RESOLUTION HOLDING HEARING ON REQUEST FROM EASTGATE PLAZA, LLC AND NET LEASE DEVELOPMENT, LLC FOR THE 6TH AMENDMENT TO THE EASTGATE PLAZA PUD CONCEPTUAL PLAN FOR PROPERTY LOCATED IN THE VICINITY OF 1500 EAST EUCLID AVENUE

Communication from the City Plan and Zoning Commission advising that at their September 2, 2021 meeting, the following action was taken regarding a request from Eastgate Plaza, LLC (owner), represented by Norman Weinstein (officer) and Net Lease Development, LLC (purchaser), represented by Mark Huonder (officer), for review and approval of a 6th amendment to the Eastgate Plaza PUD Conceptual Plan on property located in the vicinity of 1500 East Euclid Avenue, to allow development of a 2.09-acre parcel with a restaurant building with a drive-up window and a multiple-tenant commercial building.

EASTGATE PUD CONCEPTUAL PLAN

SP-1

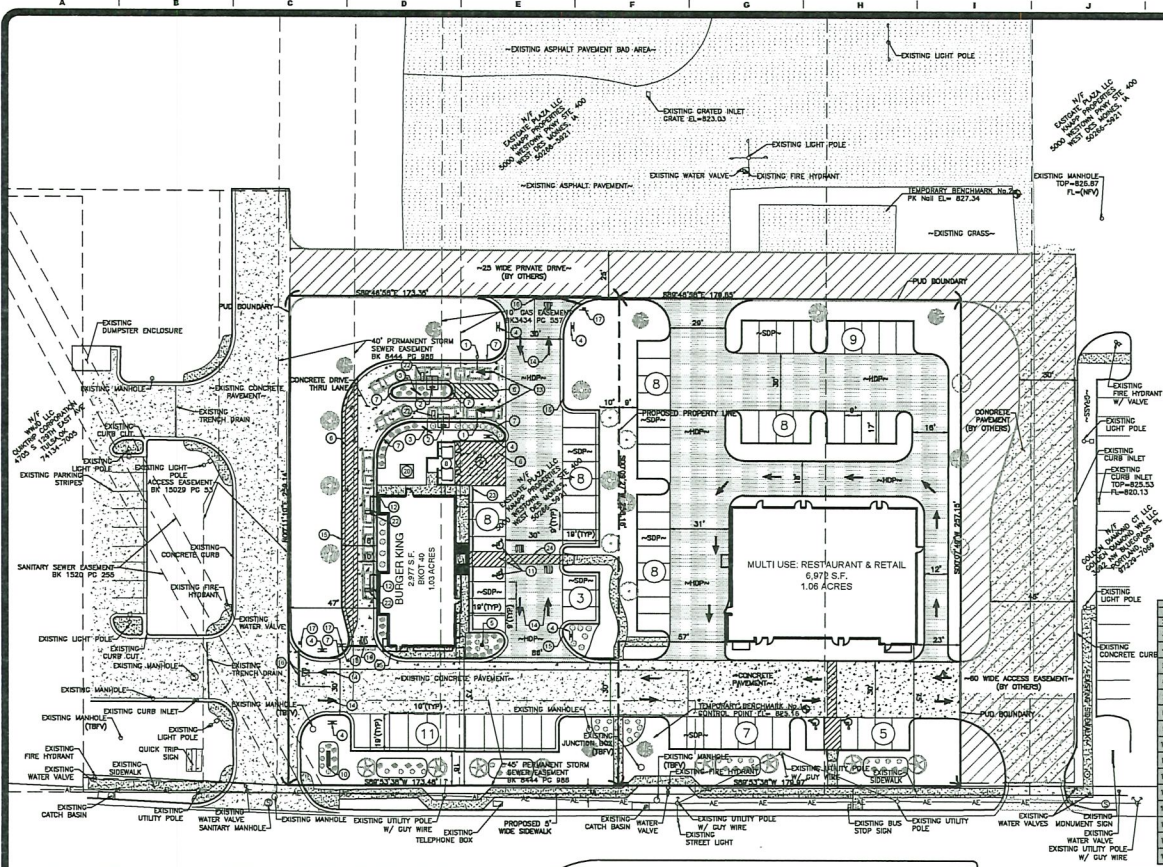
2. **Utilities:** The subject property has access to necessary utilities. There are both public storm and sanitary sewer crossing the site within easements. These affect the placement of the building and require that it be shifted east of the existing storm water facilities.

3. **Traffic/Connectivity:** The site would be accessed from two (2) driveways from East Euclid Avenue and an internal driveway from the existing convenience store to the west and from the existing medical office building to the east. Both the western drive entrance and the eastern drive entrance would align with existing median cuts in East Euclid Avenue. The "PUD" Conceptual Plan also provides cross-access through the property to the north and both east and within the overall Eastgate Plaza commercial center.

Staff recommends that the easterly north/south driveway be constructed to appear to be street to the satisfaction of the City's Planning Administrator, with features such as parallel parking stalls, Class A sidewalks, and street trees.

Staff also recommends provision of a note to state that pedestrian access to the adjoining parcels to the east, west, and north shall be provided in anticipation of future pedestrian connectivity and that all crosswalks across access drives shall be clearly striped as a pedestrian path.

- 1) Provision of a note that states that the easterly north/south driveway (to the east of the proposed multiple-tenant commercial building) shall be constructed to appear to be street to the satisfaction of the City’s Planning Administrator, with features such as parallel parking stalls, Class A sidewalks, and street trees.

- 3) Provision of a note that states any building shall not be located within any necessary utility easement.
- 4) Provision of a note that states that bike rack quantity, placement, and design shall be provided in accordance with Chapter 135: Planning and Design Code.

- 5) Provision of a note that states that pedestrian access to the adjoining parcels to the east, west, and north shall be provided in anticipation of future pedestrian connectivity and that all crosswalks across access drives shall be clearly striped as a pedestrian path.

LANDSCAPE PLAN

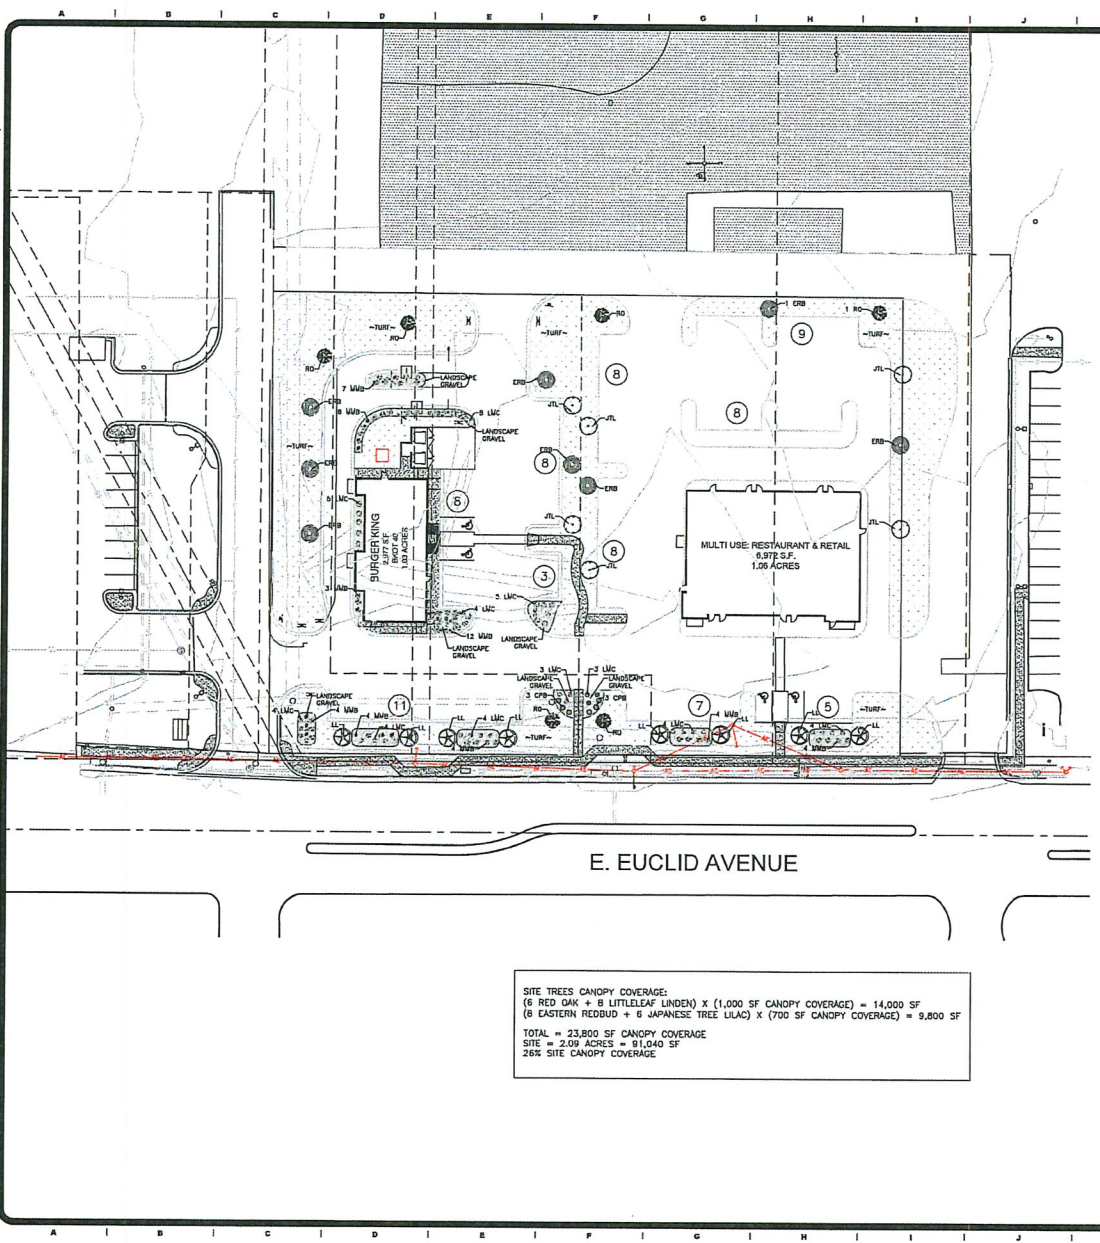
5. **Landscaping:** The proposed “PUD” Conceptual Plan demonstrates that landscaping and plantings are to be provided throughout the site and along the frontage.

Staff recommends that landscaping to be provided in accordance with Chapter 135: Planning and Design Ordinance and that a continuous row of shrubs or grasses be provided along the west side of the drive-through facility.

Staff also recommends provision of a 3-foot tall decorative wrought iron fence, supported by brick columns that match the primary structure, along the south frontage of the area and that perimeter plantings required by the landscape standards shall be provided between the fence and the south property lines.

- 6) Provision of a note that states that landscaping shall be provided in accordance with Chapter 135: Planning and Design Ordinance.
- 7) Provision of a note that states that continuous row of shrubs or grasses shall be provided along the west side of the drive-through facility.

- 8) Provision of a note that states that a 3-foot tall decorative wrought iron fence, supported by brick columns that match the primary structure, shall be constructed along the south frontage and that perimeter plantings required by the landscape standards shall be provided between the fence and the southerly property line.

A-2

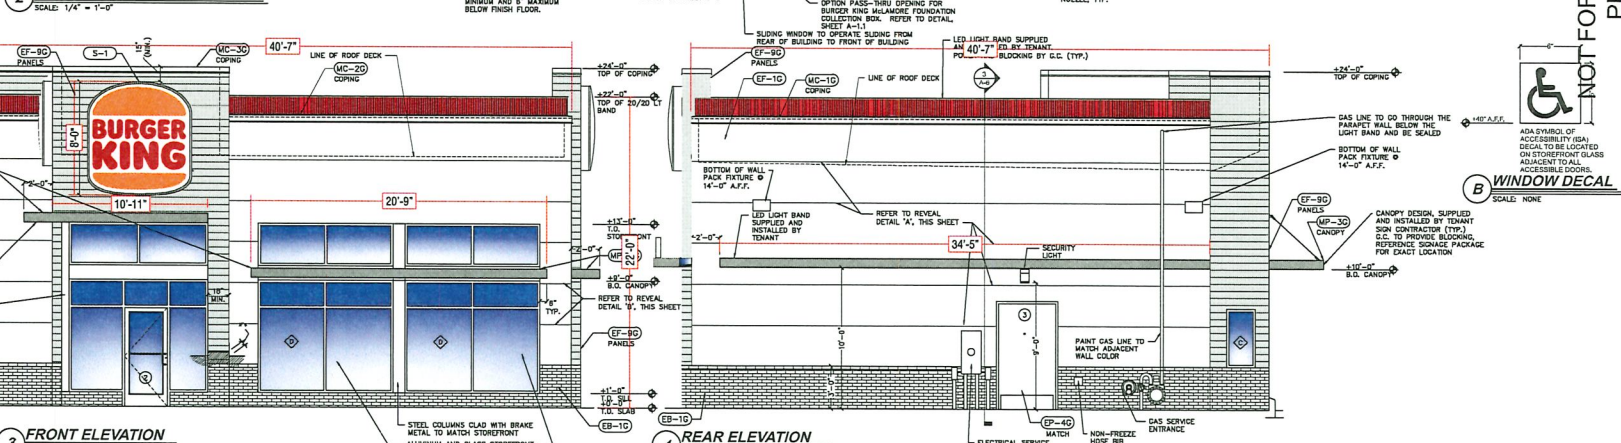
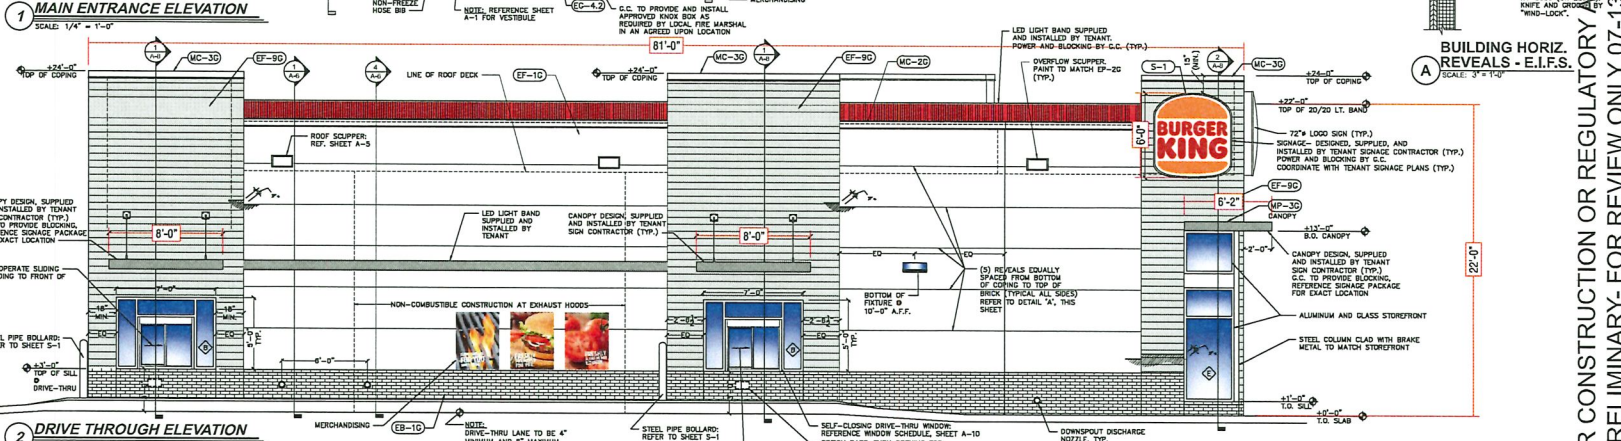
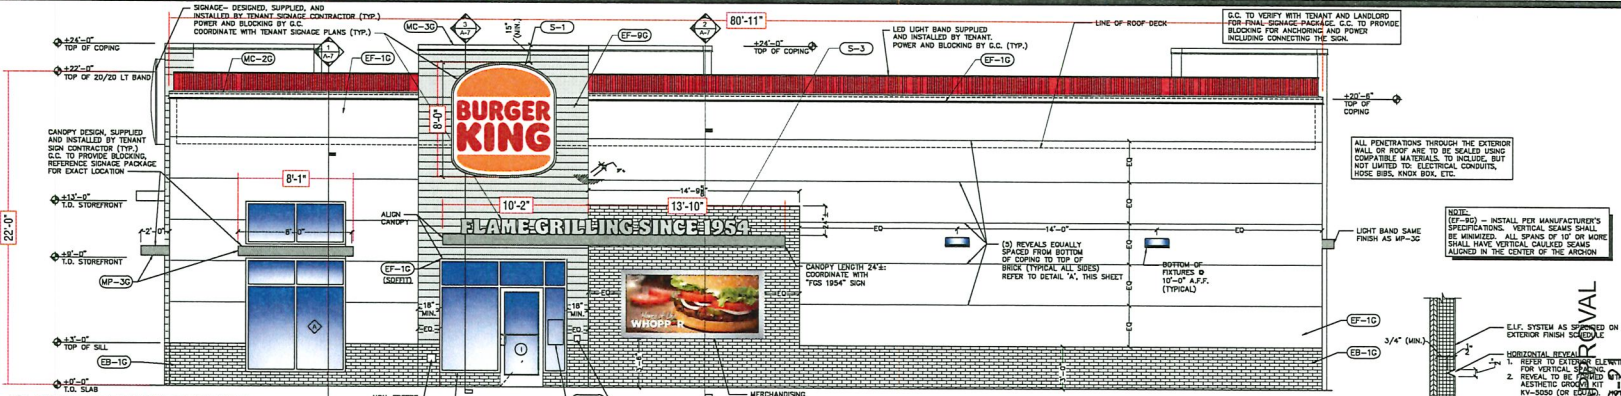
6. **Urban Design:** The proposed “PUD” Conceptual Plan demonstrates that the proposed fast-food restaurant building would be constructed to blend with the current surrounding building materials. It indicates that the building would be sided with a combination of stucco system, facebrick, and fiber cement panels.

Staff recommends that all stucco shown on the building elevations shall meet the standards necessary in order to be considered as a “Major Façade Material” prohibiting EIFS materials, as regulated in City Code Chapter 135 and that all brick shown on the building elevations shall be full-dimensional brick and not thin brick.

- 9) Provision of a note that states that all stucco shown on the building elevations shall meet the standards necessary in order to be considered as a "Major Façade Material" prohibiting EIFS materials, as regulated in City Code Chapter 135.

- 10) Provision of a note that states that all brick shown on the building elevations shall be full-dimensional brick and not thin brick.
- 11) Provision of a note that states that all mechanical equipment, roof top units, condensers, meters, transformers or other such equipment shall be provided, including the undergrounding of all overhead utilities whenever reasonably practicable, in accordance with Chapter 135: Planning and Design Code.
